BRIDGE MICRO-MILL DETAIL
BRIDGE II M.M. 2.260 MONTGOMERY

PROJECT NAME:	BELVIDERE - BERKSHIRE
PROJECT NUMBER:	STP SURF(53)
FILE NAME:	I4v204\pi4v204.dgn\pi4v204_36.1
PLOT DATE:	26-JAN-2016
PROJECT LEADER:	M. FOWLER
DRAWN BY:	K. LOCKE
DESIGNED BY:	K. LOCKE
CHECKED BY:	M. FOWLER
BRIDGE DETAIL SHEET 1	SHEET 36 OF 45

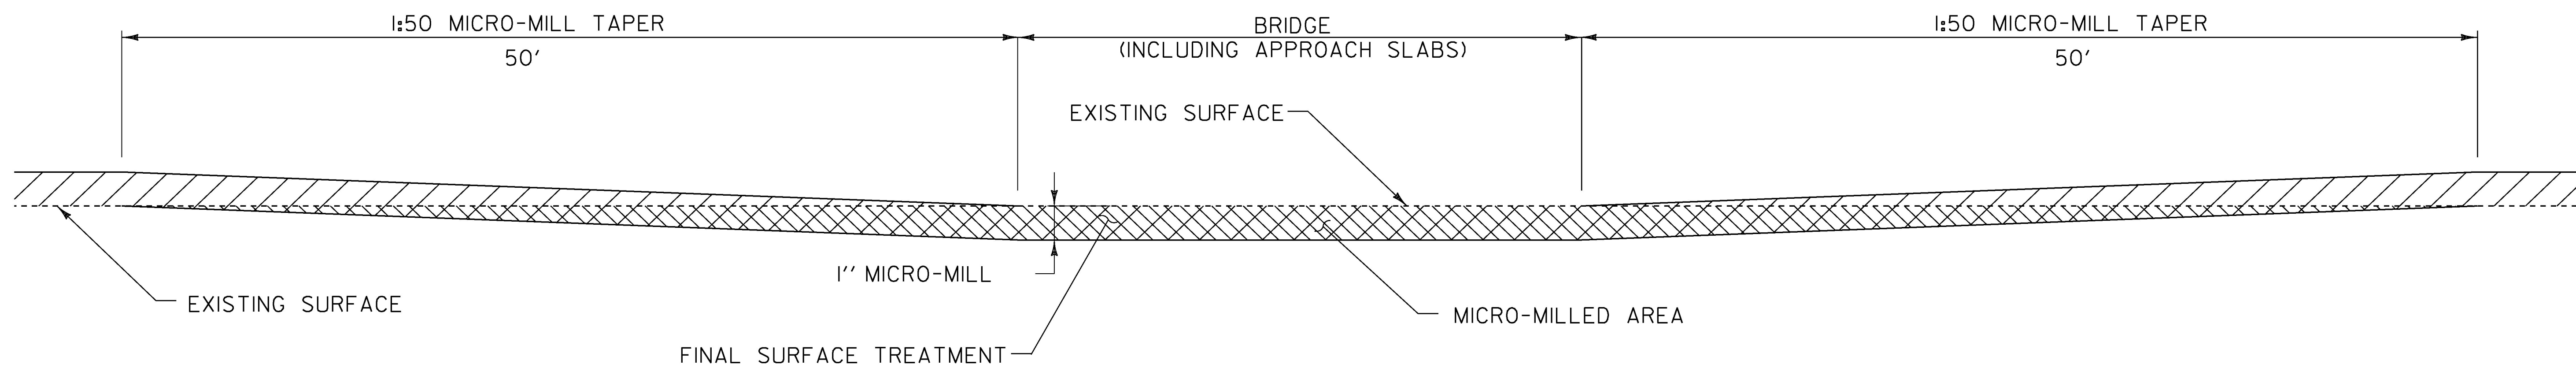
REVISION	DATE	DESCRIPTION	BY
△	01-27-16	CHANGED MICRO-MILL DEPTH TO 1" FROM 3/4". CHANGED MICRO-MILL TAPER LENGTHS.	KML
